FINAL
EXTENDED REMEDIAL INVESTIGATION REPORT
Installation Restoration Program Site 27

NAVAL WEAPON STATION SEAL BEACH
DETACHMENT FALLBROOK
FALLBROOK, CALIFORNIA

Naval Facilities Engineering Command Southwest
Contract Number: N62583-09-D-0143, DO #0003
DCN: ECS-0143-0003-0208

July 2014

**FIGURE
3**

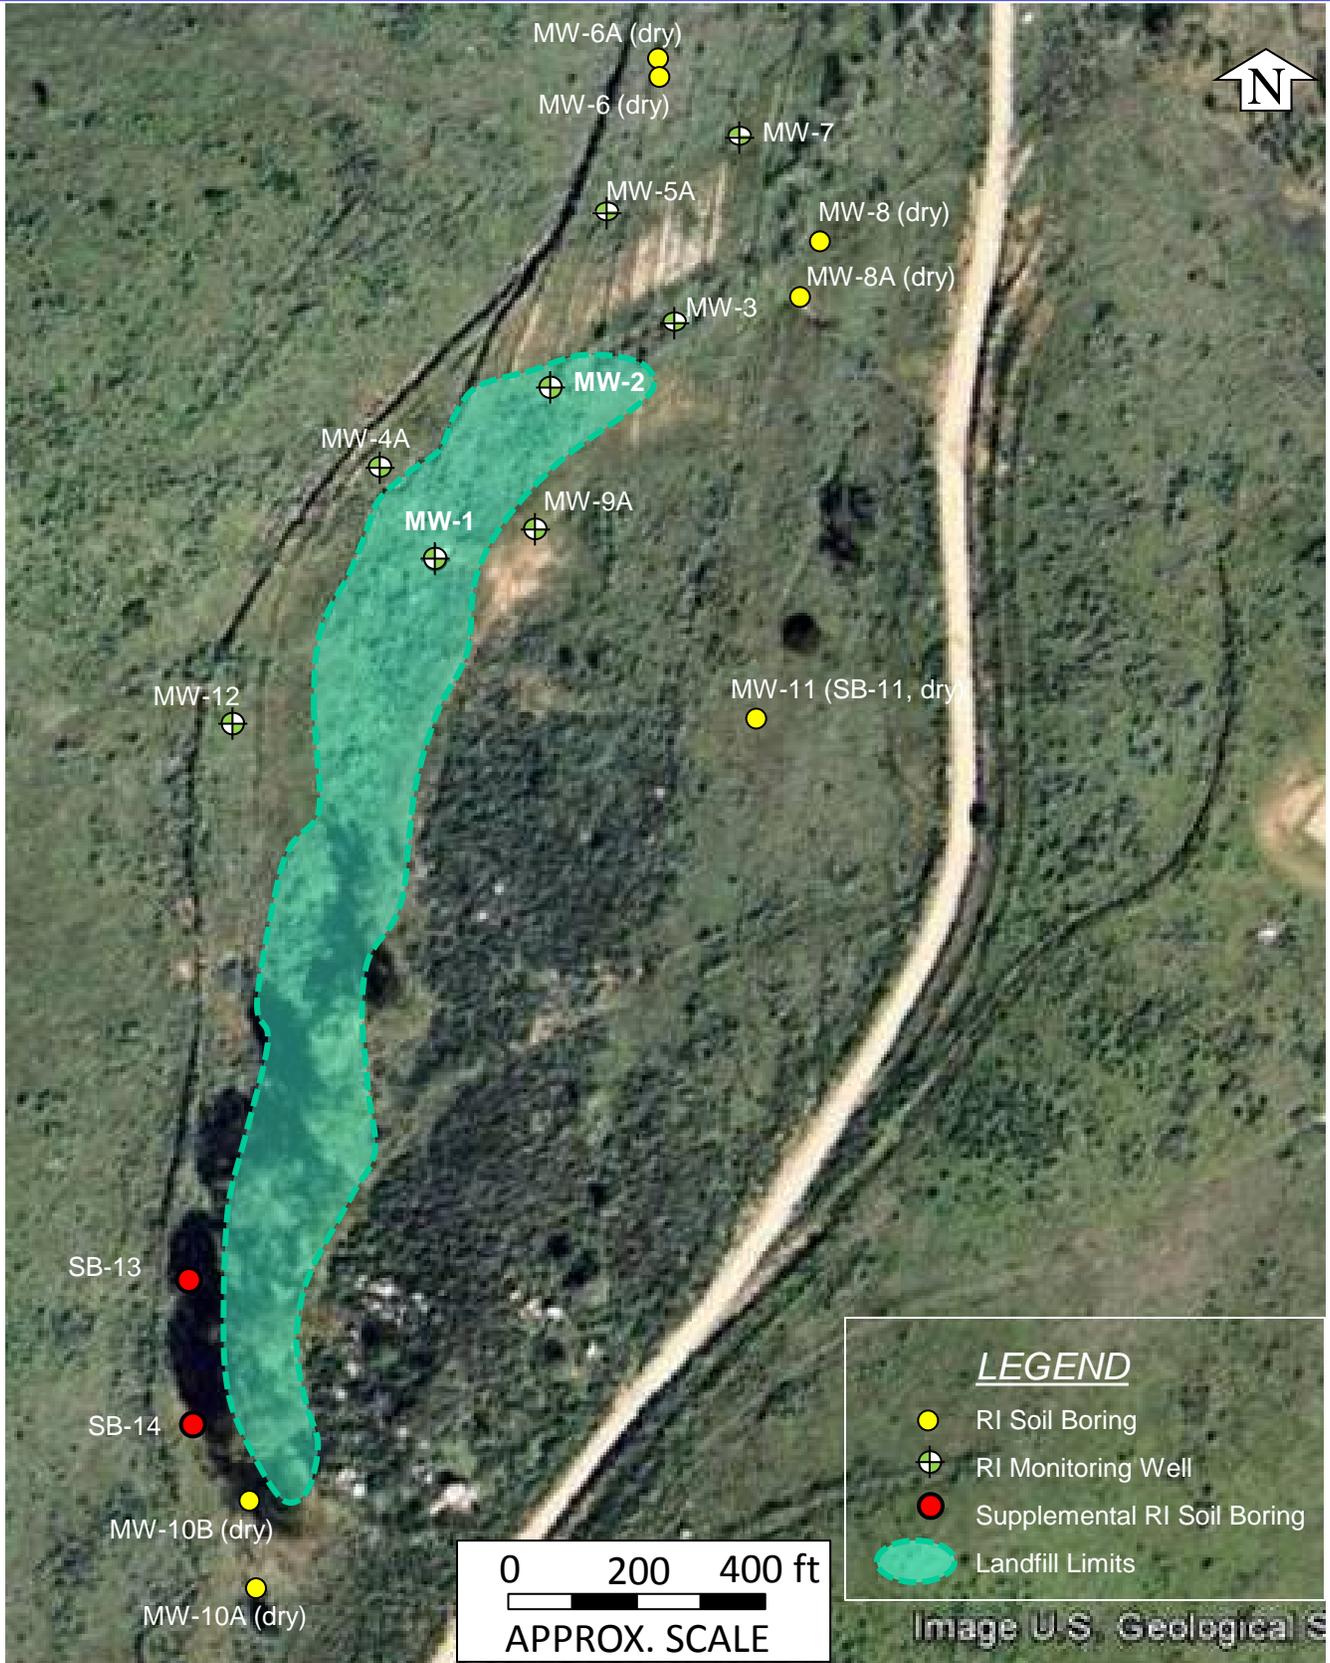
ecological receptors associated with the nearby ravine and "seasonal pond" (Draft Report, Figure 3), located downgradient of the Site. The SLERA (Draft Report, Subsection 7.3.2) does not address the potential for Site groundwater to "daylight" and become surface water within the ravine located approximately 200 feet northeast and flow into the "seasonal pond" located approximately 1,200 feet north of the Site. Both of these surface water bodies are located downgradient of the Site. The hydrologic communication between groundwater and surface water is known to occur and it is not apparent as to why this matter is not addressed from a SLERA perspective at this Site. In the RTC, please either provide the rationale as to why this matter is not a concern at the Site or a revised Draft Report, Subsection 7.3.2, that discusses the potential for groundwater to adversely impact receptors associated with these two surface water bodies, whichever is appropriate.

(DQO) process detailed in the approved Final RI Work Plan (SES Tech 2010). The study boundaries did not include sampling of surface water in the seasonal pond 1200 feet north of the site, nor in the ravine that is tributary to it. The data are therefore lacking to evaluate the hypothetical recharge of surface water by groundwater if it indeed occurs within these topographic features.
